RE: **PUBLIC** Comments of the Minnesota Department of Commerce
Docket No. E002/M-25-142

In the Matter of Xcel Energy's 2025 Integrated Distribution Plan.

Xcel Energy's (Xcel or the Company) Integrated Distribution Plan (IDP) was filed on October 31, 2025. Xcel's Transportation Electrification Plan was filed concurrently.

Figure 26: Xcel Line Utilization by Planning Division (Avg Energy Use / Rated Capacity)

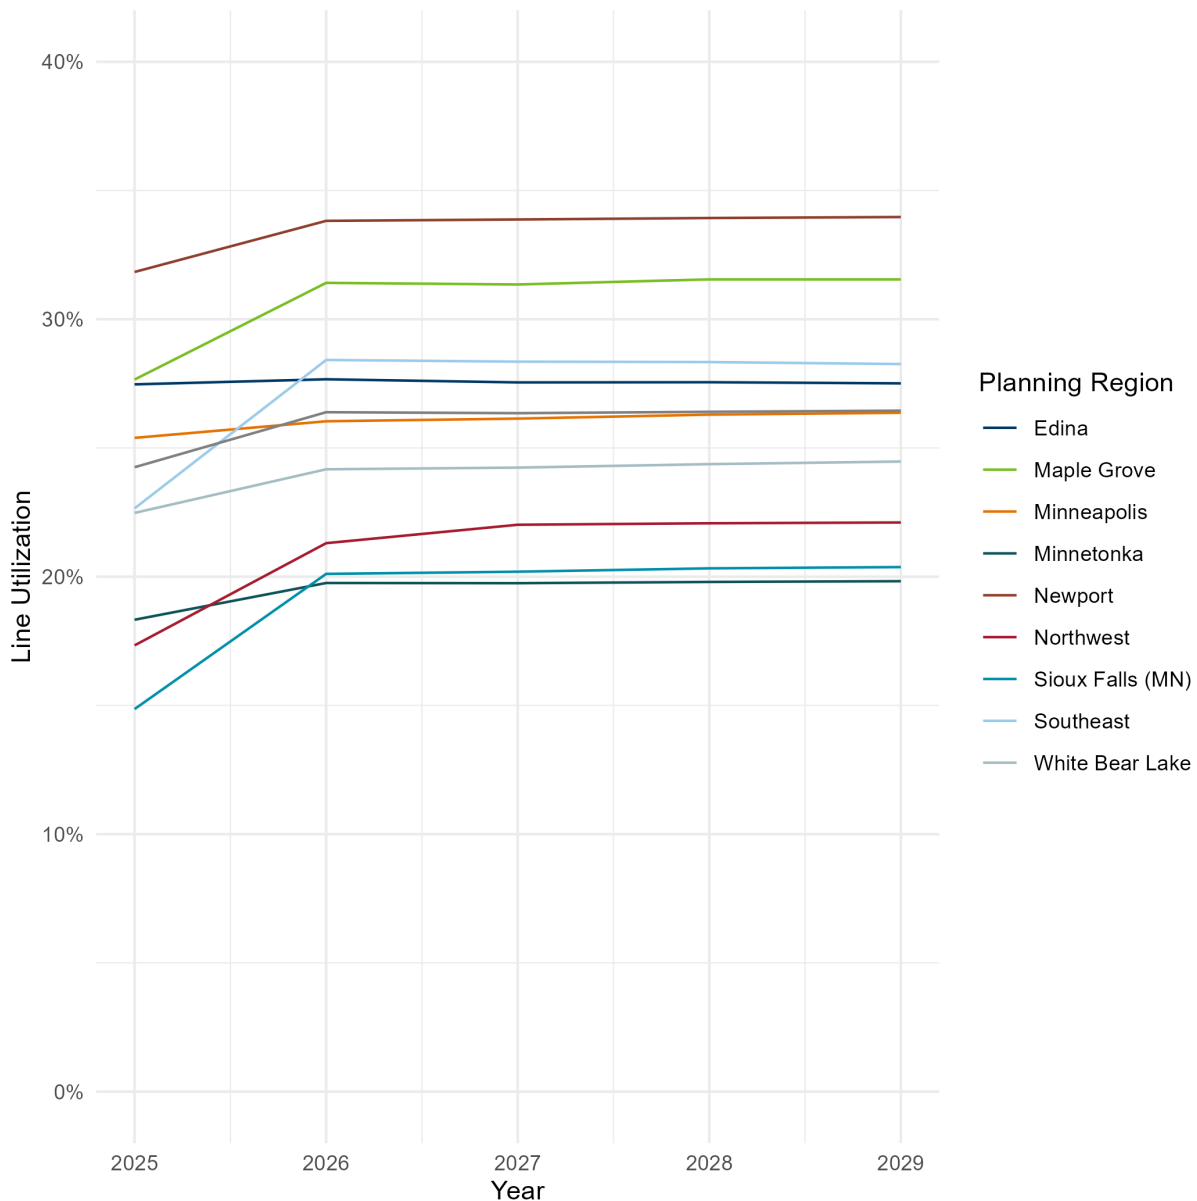
[TRADE SECRET DATA HAS BEEN EXCISED] Generally, most feeders in Xcel's territory have ample capacity for switching, as demonstrated by Xcel's line utilization data from IR 13 shown in Figure 26.⁹¹

The probability of rare N-1 peak day outages and their consequences must be weighed against Xcel’s planned budget to mitigate these risks. Xcel plans to spend \$293 million to mitigate N-1 risks listed in Attachment E,⁹² which represents less than half of Xcel’s 5-year capacity budget.⁹³ With an estimated annual N-1 risk capacity budget of \$141 million,⁹⁴ it is important to evaluate whether these costs are

Figure 29: Relationship between Overhead Line Miles and Customer Minutes Out for Feeders in Xcel’s Service Territory.

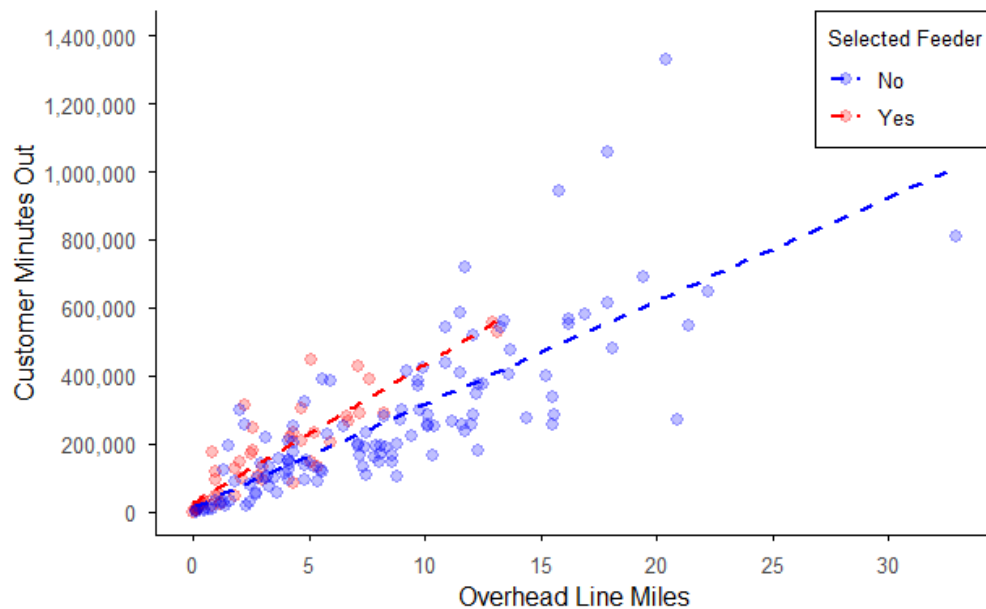
Figure 29 offers empirical support for the Targeted Undergrounding Plan through the demonstration of a clear correlation between overhead line miles and customer minutes out. The linear relationship confirms that feeders with extensive overhead infrastructure experience more significant service

interruptions, which provides justification for the strategic relocation of high-risk segments to improve system resilience and reduce total outage durations. More importantly, the higher rate of accumulation for feeders selected for undergrounding (Selected Feeders ‘Yes’), represented by a steeper slope, demonstrates that the First Targeting Method Scenario prioritized feeders with the highest outage impact relative to the overhead line miles. By targeting these higher-value feeders, the method focuses resources on the specific assets where the reliability gains per undergrounded mile are most significant. While the linear relationship provides a high-level physical justification, it fails to account for the diminishing returns of undergrounding in areas where outages are driven by equipment failure or lightning rather than trees and wind.

Figure 34: Xcel Spending by Budget Category and Planning Division

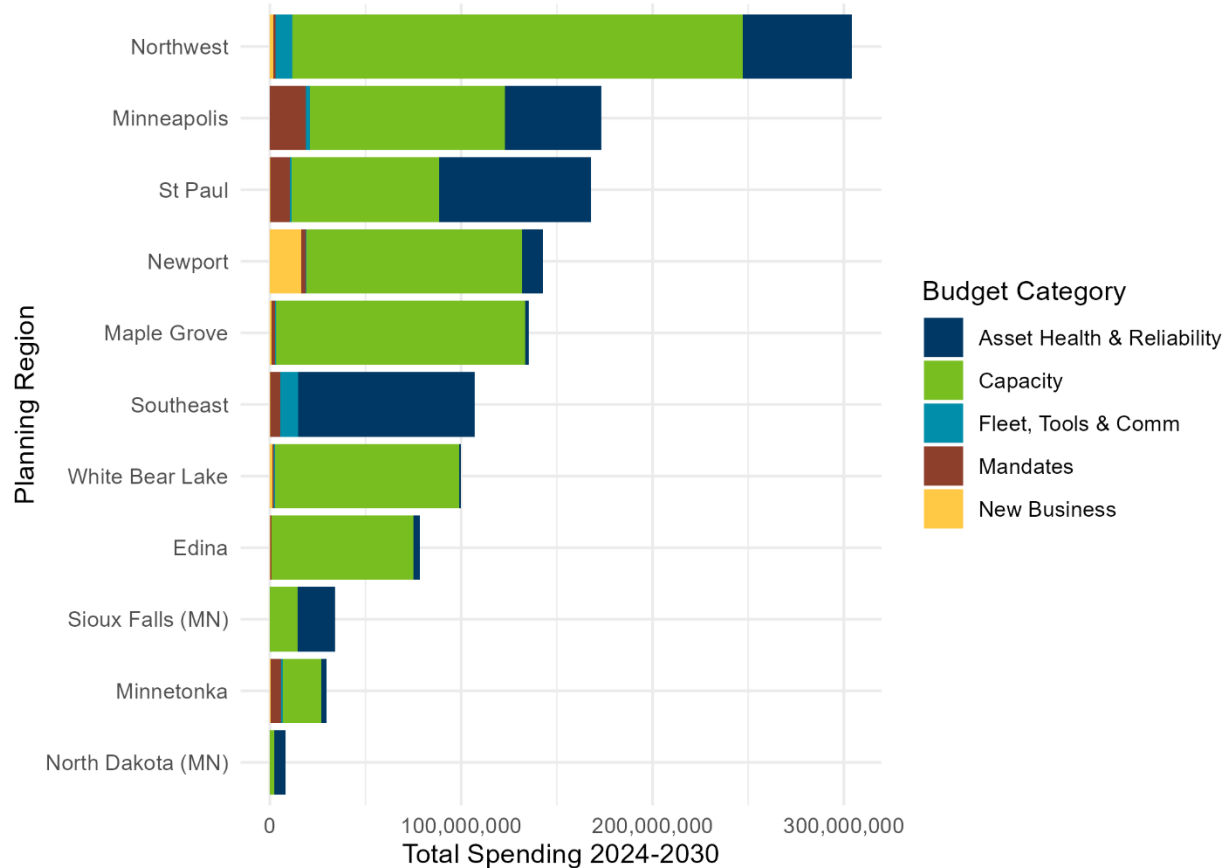
The variation in forecasted distribution spending across PD shown above—particularly the differing balance between asset health-driven investments and capacity-driven investments—cannot be explained by population growth alone.
